Subject: Re: A12 inquiry and Colchester Cycling Campaign

A12 Consultation Initial Response

A12: Response to Supplementary Consultation

Application by National Highways for an Order Granting Development Consent for the A12 Chelmsford to A120 Widening Scheme Project

2 Stanway to the Marks Tey bridge (blue dotted line for clarity):

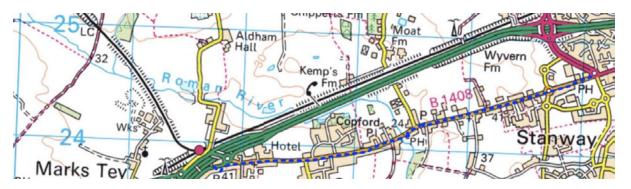
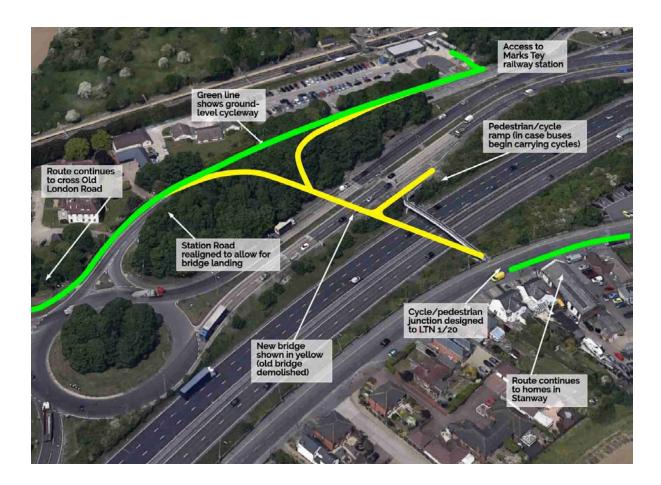
1. <u>Marks Tey to Boreham (green dotted line for clarity)</u>: A cycle route along the southeast side of the road all the way from Marks Tey to Boreham (green dotted line). This should be a continuous, machine-laid route with priority over most side roads. This would offer commuters a real alternative to the car; note that since the advent of the electric bike, Dutch commutes have increased in length and long-distance commuting routes have become more popular. The current route peters out at Easthorpe Green Farm.

This would connect the thousands of homes being built in Stanway to enable residents to reach Marks Tey railway station for commuting purposes.

2a A revolutionary Marks Tey bridge

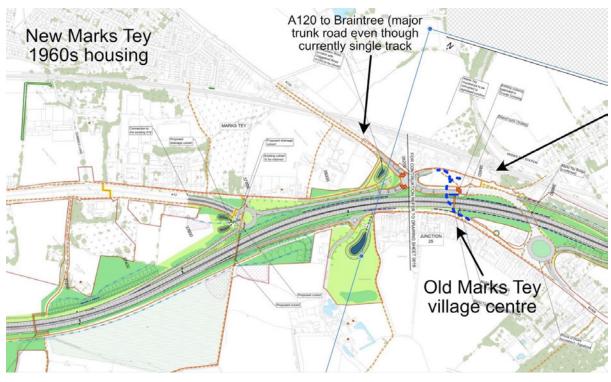
A new Y-shaped cycle/pedestrian bridge from Marks Tey south of the A12 to the railway station and Station Road/Old London Road on the north side of the A12. Note that this would rejoin the two halves of the village that have been split by the road for so long and also serve rail commuters living in the thousands of new homes in Stanway.

The northern landings would be outside the station entrance and (heading west) on the north side of Station Road (which may have to be realigned), with a spur to a westbound bus stop on the A120 (shared-use paths next to the A120 from the Prince of Wales roundabout would become redundant; the signalised crossing could be removed). Consultancies with experience of designing such bridges include and Examples can be found on their websites.
